Beall's Mount: Preliminary Plan No. 120160230

Staff Report Date: 11/28/16

Request to subdivide an unrecorded parcel to create three lots for three detached single-family dwellings; located at 12220 Stoney Creek Road, 500 feet south of Meadow Farm Road; 21.59 acres; RE-2 zone; 2002 *Potomac Subregion Master Plan*.

Staff Recommendation: Approval with conditions.

Figure E – Buffer Averaging

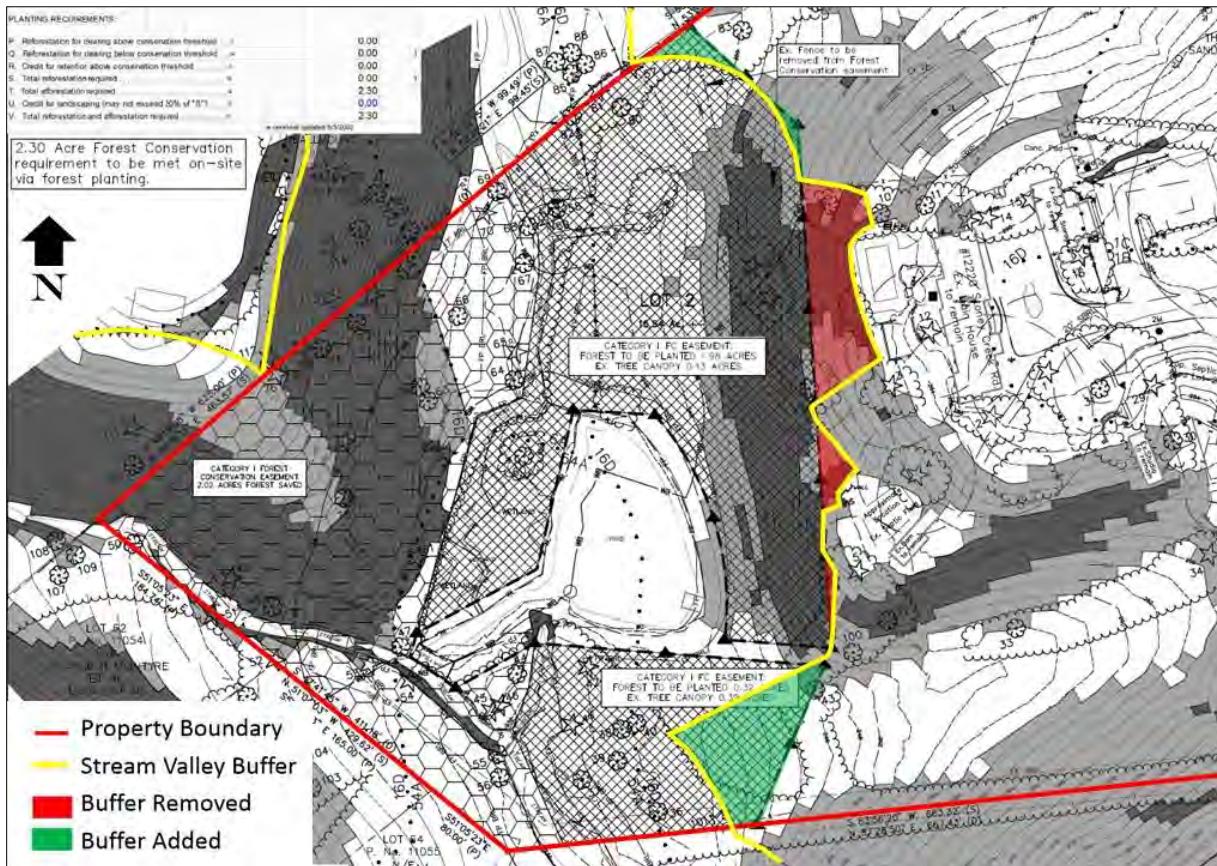
The proposed boundary of the Easement at the rear of the existing house differs in some locations from the approved stream valley buffer (“SVB”) shown on the Preliminary Plan and the NRI/FSD. In this case, the SVB, which is located at the top of the steep slope, would be immediately adjacent to the existing pool and residential structure allowing no spacing between the residential living space and the Easement. Staff recommends creating a 40-foot gap between the existing residential structure and the Easement boundary to reduce any potential Easement violations in the future. To compensate for the amount of SVB not protected by the proposed Easement, the process of buffer averaging was used.

The Applicant does not propose any encroachments into the approved SVB. The SVB line runs along the top of the steep slope on which the existing structure was placed. The SVB is directly adjacent to the pool structure leaving no gap between the structure and the proposed

conservation easement to allow maintenance or access. To avoid any potential forest conservation easement violation in the future it was decided to place the easement line 40-feet west of the pool structure instead of following the SVB line as is typically done.

This area of the SVB that is not being protected with a Category I Conservation Easement is considered steep slopes with a grade of approximately 30%. This area of the SVB is an open grassed area with scattered trees. Except for this area of SVB not within the proposed Easement the remaining environmentally sensitive areas have been avoided by locating the proposed dwellings and associated well and septic systems in front of the existing house, closer to Stoney Creek Road.

The Applicant proposes to use “stream buffer averaging” to compensate for the amount of SVB not being protected with Easement. The area of SVB not included in the proposed Easement is approximately 8,815 square feet. As compensation, the Applicant proposes to place 8,980 square feet of additional land outside of, but adjacent to, the SVB into Easement. This additional area will be planted with new forest. The loss in SVB protection has been compensated for by increasing the area of conservation easement outside of and adjacent to the SVBs, both southeast and northeast of the existing farm pond near the Property lines.

Figure F – Forest Conservation

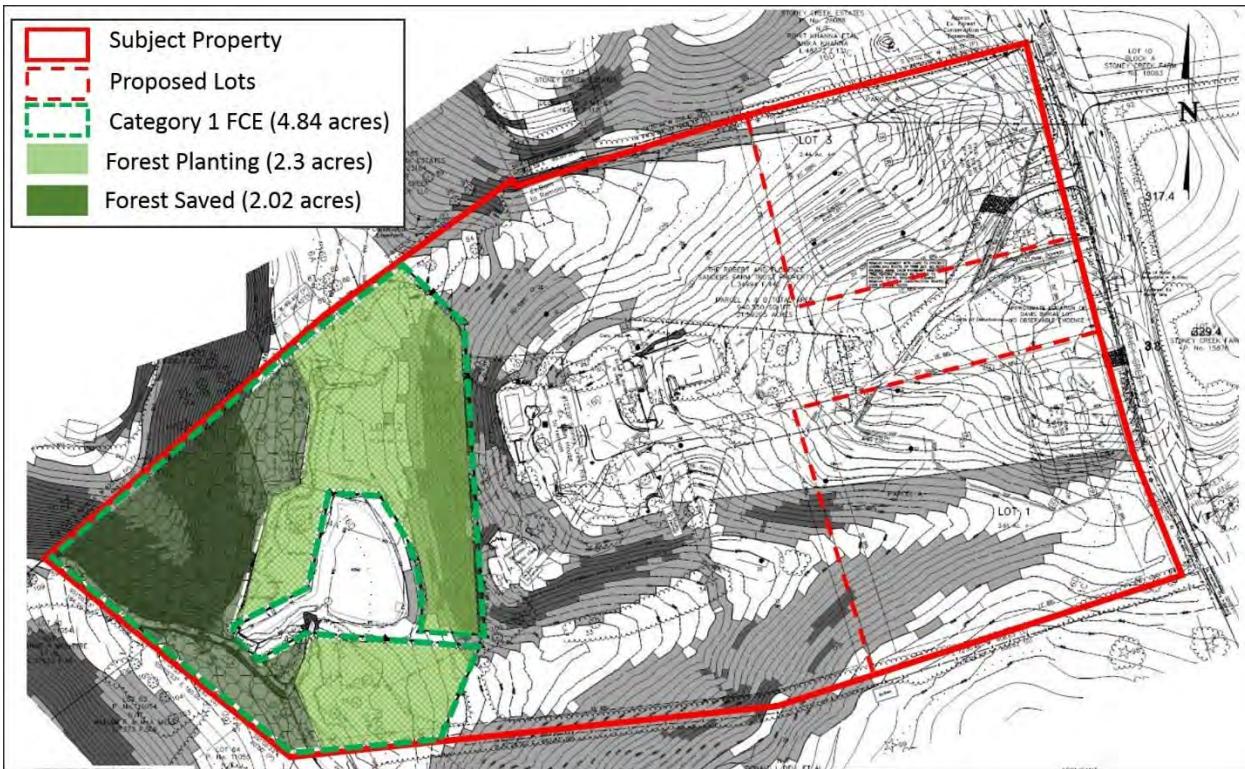
The Application meets the requirements of Chapter 22A of the Montgomery County code. An FCP has been submitted for review as part of this Application (Attachment 7). Based on the total tract area of this parcel and the Land Use Category on the Forest Conservation Worksheet, development of this site results in an afforestation requirement of 2.30 acres. The Applicant proposes to meet this requirements of the forest conservation plan by retaining the 2.02 acres of existing high priority forest and planting 2.30 acres of SVB. All retained forest, planted forest, SVB and wetland areas shown on the FCP will be placed into a Category I Conservation Easement. The existing pond, spillway and maintenance access path to the pond will remain outside of any conservation easement in order to allow periodic maintenance to be performed on this structure.

Figure G – Specimen Trees Impacted

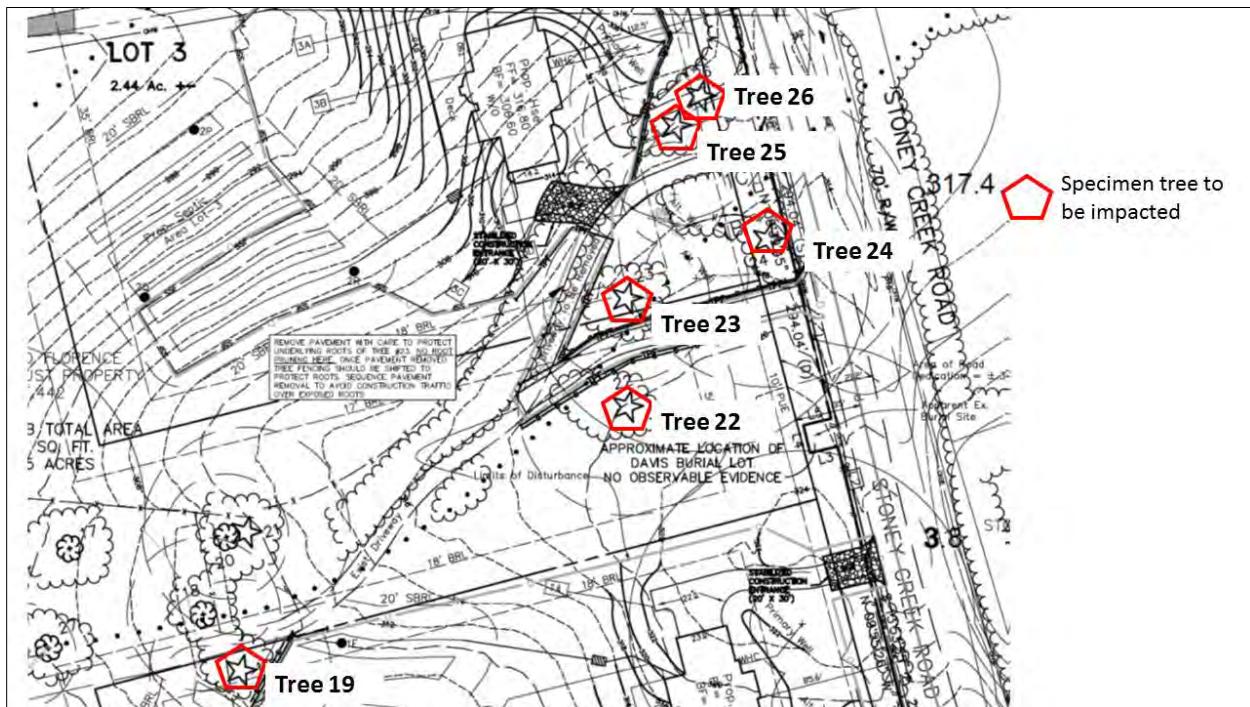
The *2002 Potomac Subregion Master Plan* recommends RE-2 for this area with limited sewer and water line access. As a result, this Property relies on well and septic systems. The location of the proposed homes is dictated by the location of the wells and septic systems and the building restriction lines on each of the lots. Lot 3 is particularly constrained in this regard which results in the unavoidable impacts to four trees (Trees 23-26). Lot 1 in turn also impacts one tree (Tree 19) due to the placement of the required septic field for the proposed house. Tree 22 will be impacted by the realignment of the entry drive south of Tree 22 for the existing house. However, some of the impacts to Tree 22 are being off-set by the careful removal of the existing driveway in the northeast region of the tree's CRZ.

The arboriculture industry standard for construction impacts to trees is to limit those impacts to no more than approximately 30 percent of the CRZ. More than 30 percent impact to the CRZ and the overall

healthy viability of the tree comes into question. Trees #19, #22, #24, #25 and #26 will have approximately 20 percent to about 30 percent of their CRZs impacted and are expected to recover from this damage given the appropriate follow-on care. Tree #23 is projected to have 49 percent of its CRZ impacted and will require additional protective and follow-on care to recover from this impact.

ATTACHMENT 4

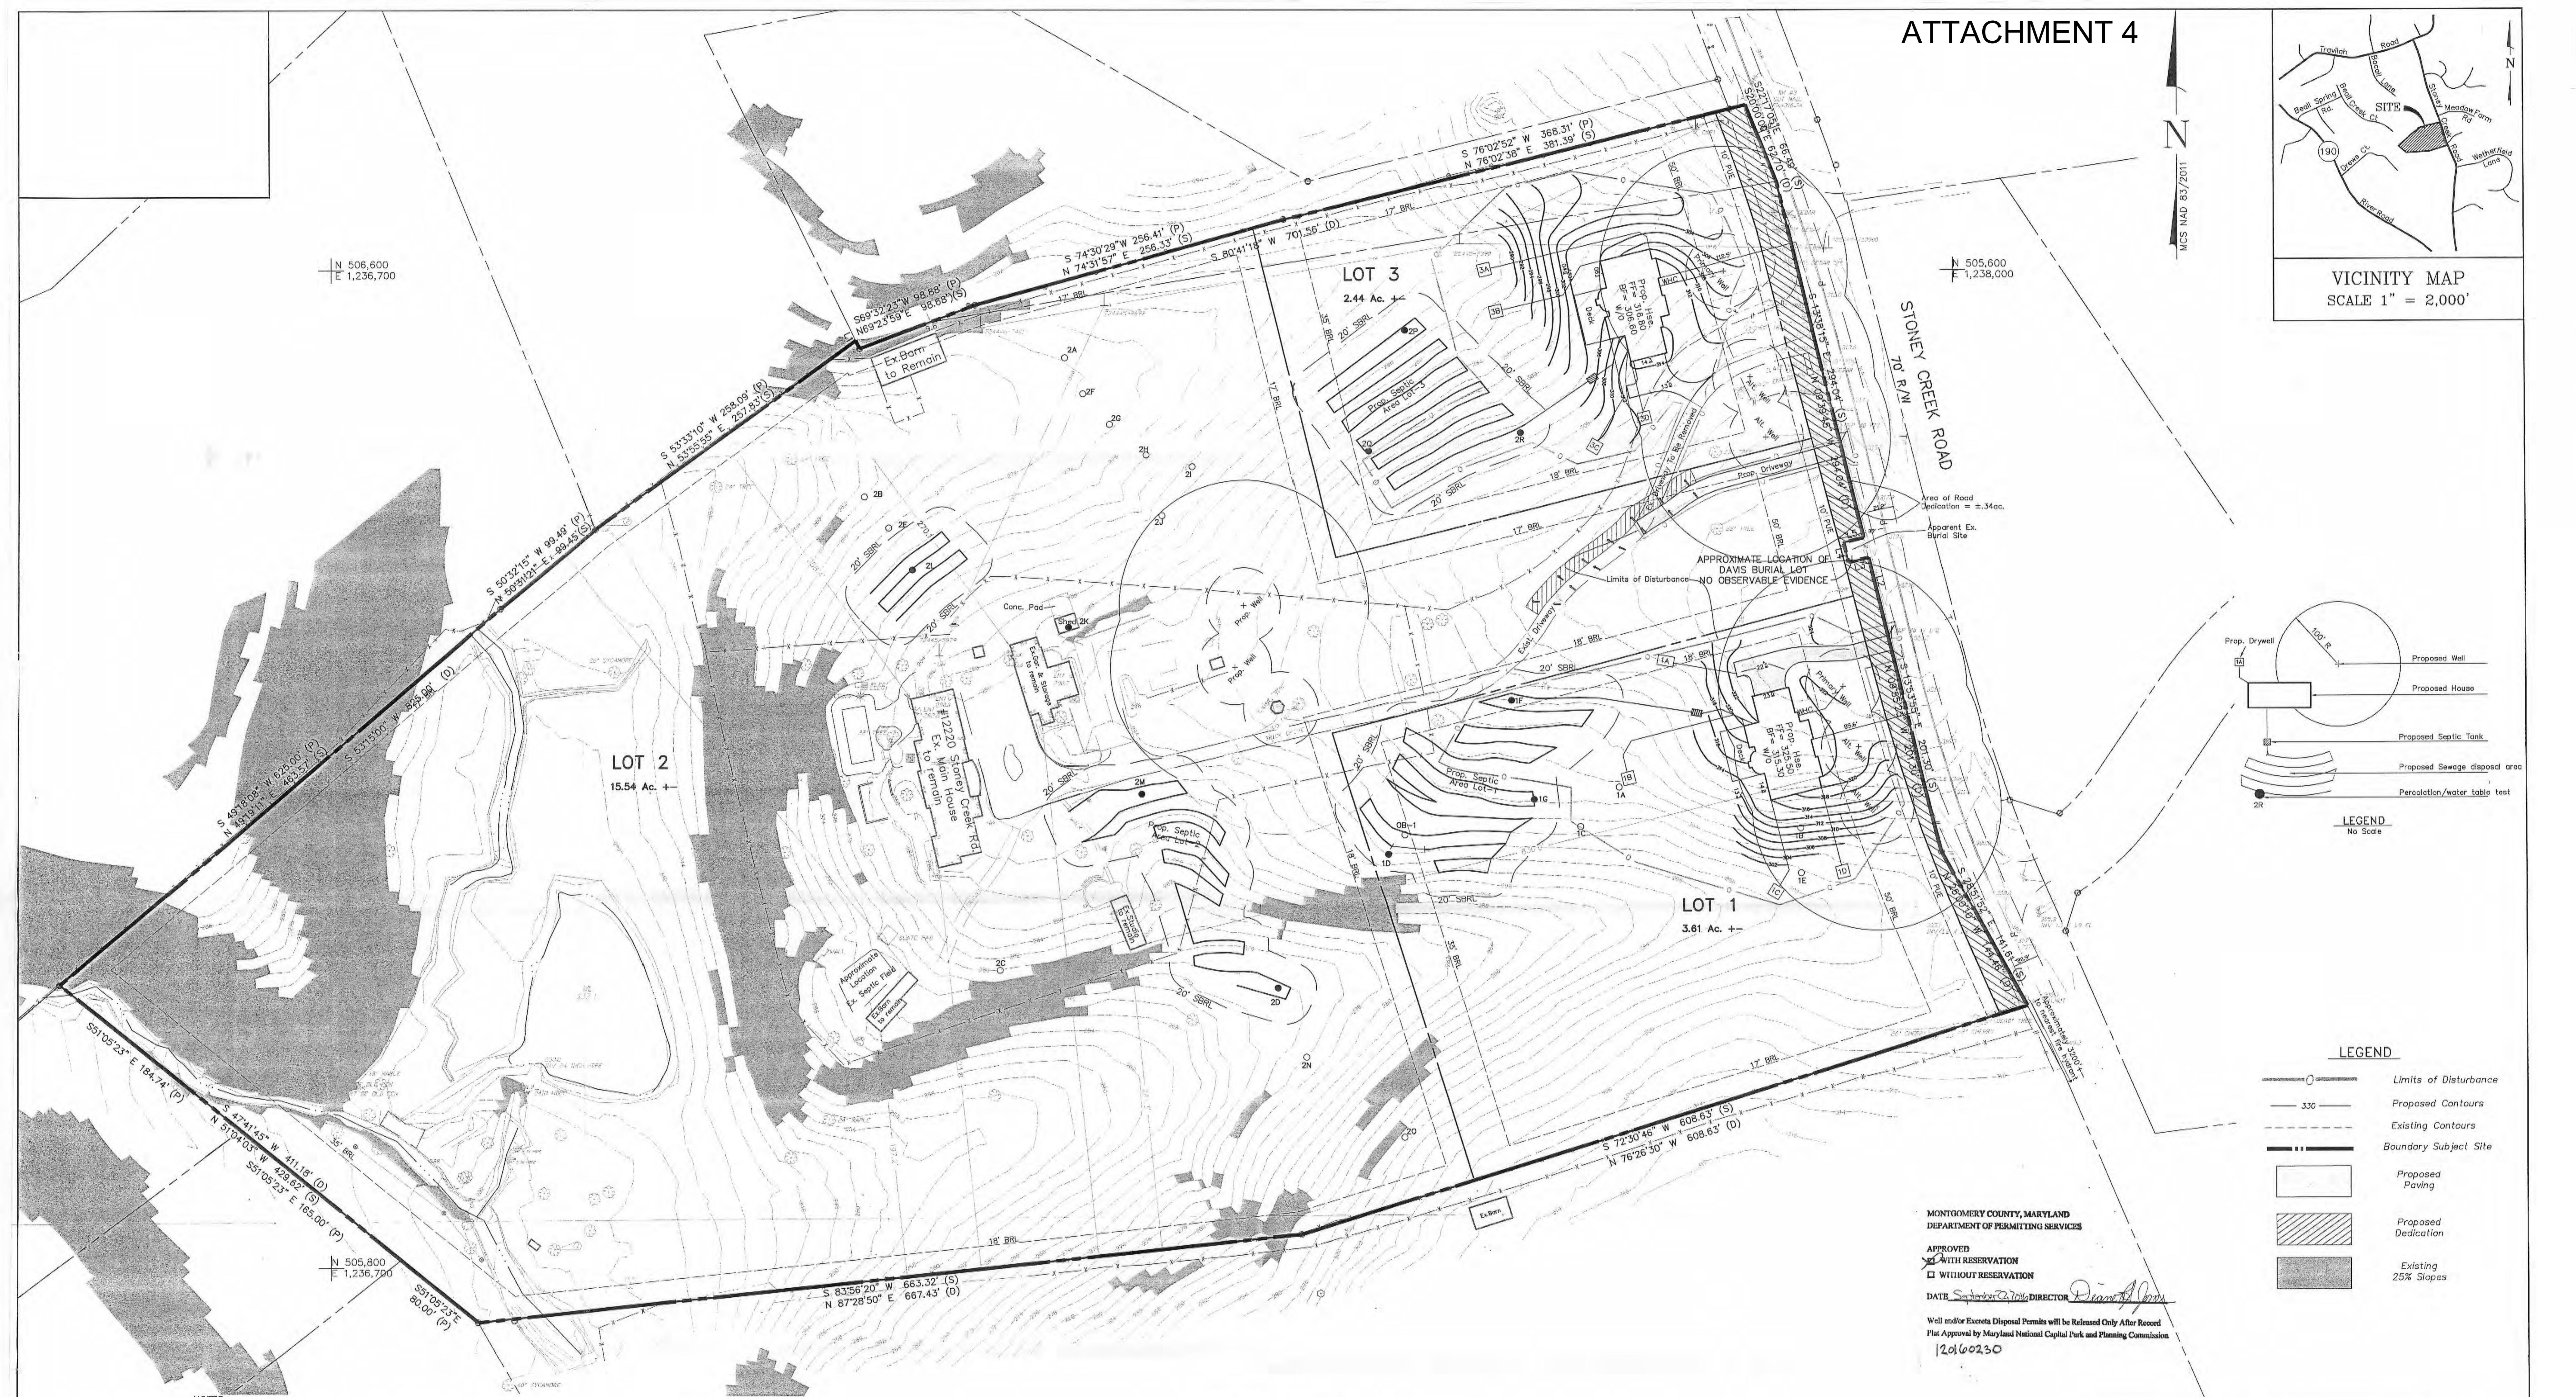
This is to notify you that the Well & Septic Section of MCDPS approved the plan received in this office on September 14, 2106.

1. The record plat must be at the same scale as the preliminary plan, or submit an enlargement of the plat to match the preliminary plan.
2. The record plat must show the septic reserve area as it is shown on this plan.
